**POTOMAC HIGHLANDS AIRPORT AUTHORITY
MINERAL COUNTY, WEST VIRGINIA
REHABILITATE RUNWAY 5-23 BID PHASE 7**

**ADDENDUM #2
JUNE 6, 2025
THRASHER PROJECT # T80-11189**

The following drawing have been revised:
C4.01 - Demo

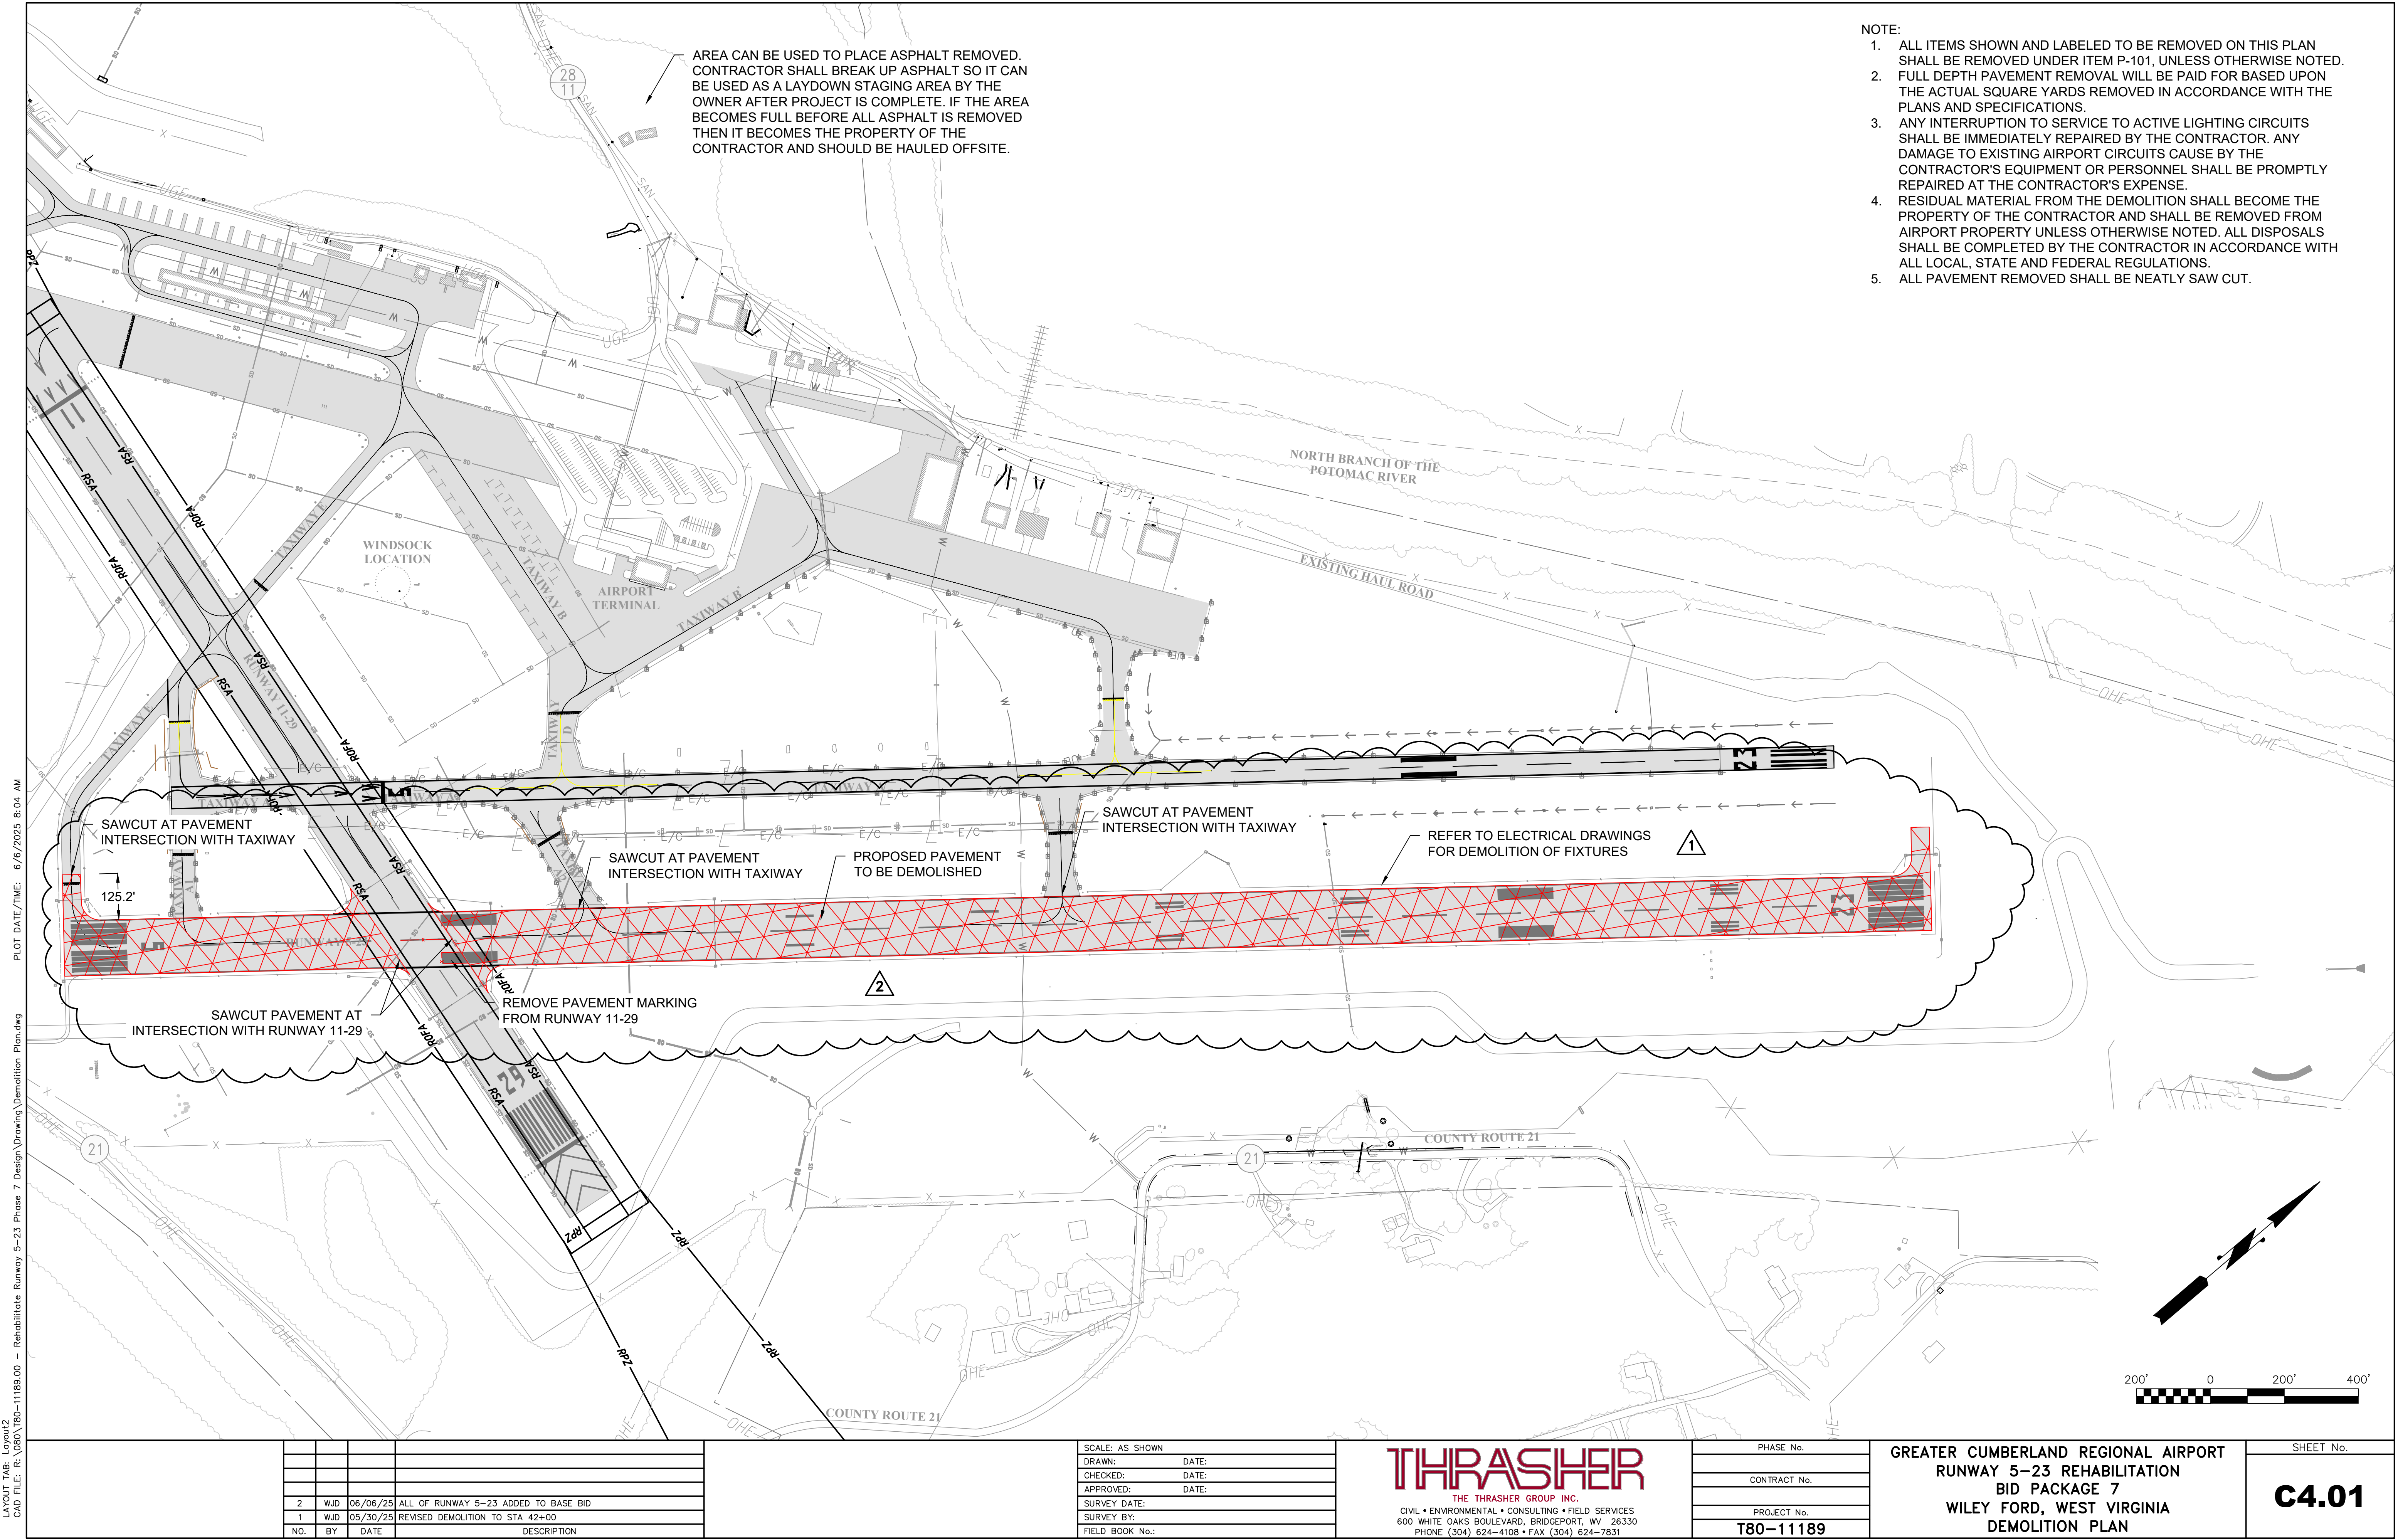
RESPONSE: All the runway pavement will be removed. A revised bid form has adjusted the quantity. The closed runway markers should remain during construction, however can be removed once the contractor is demobilizing.

AREA CAN BE USED TO PLACE ASPHALT REMOVED. CONTRACTOR SHALL BREAK UP ASPHALT SO IT CAN BE USED AS A LAYDOWN STAGING AREA BY THE OWNER AFTER PROJECT IS COMPLETE. IF THE AREA BECOMES FULL BEFORE ALL ASPHALT IS REMOVED THEN IT BECOMES THE PROPERTY OF THE CONTRACTOR AND SHOULD BE HAULED OFFSITE.
